UNITED STATES PATENT AND TRADEMARK OFFICE

APPLICATION NO.	FILING DATE	FIRST NAMED INVENTOR	ATTORNEY DOCKET NO.	CONFIRMATION NO.
10/593,535	08/20/2008	Toshiharu Takayama	8957-000007/US/NP	9968
27572 7590 02/25/2010 HARNESSE, DICKEY & PIERCE, P.L.C. P.O. BOX 828 BLOOMFIELD HILLS, MI 48303			EXAMINER GOODWIN, DAVID J	
			ART UNIT 2818	PAPER NUMBER
			MAIL DATE 02/25/2010	DELIVERY MODE PAPER

Office Action Summary	Application No. 10/593,535	Applicant(s) TAKAYAMA ET AL.	
	Examiner DAVID GOODWIN	Art Unit 2818

DETAILED ACTION

FIG. 5

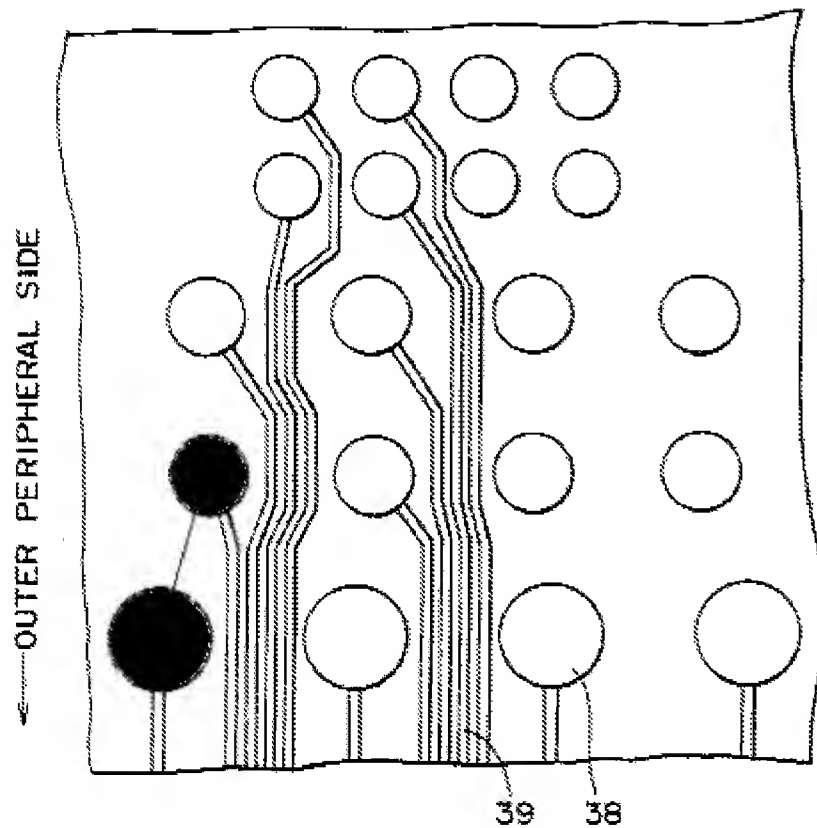
5. Note: Referring to figure 5, a plurality of lands (38) is shown. Any two of said lands (39) is a pair of lands. Said pair of lands is connected to circuit elements (39). Said circuit elements are displaced from the shortest path between the lands, said shortest path being the straight line path intersecting the center of a given electrode pair.

11. Note the pair of blackened electrodes above having a first land and a second land (fig 5). Said pair of electrodes are connected to circuit elements. Said circuit elements connected to the pair of electrodes, having the first and second lands, are laterally displaced from the shortest path connecting the center of electrode of the electrode pair (shown above).
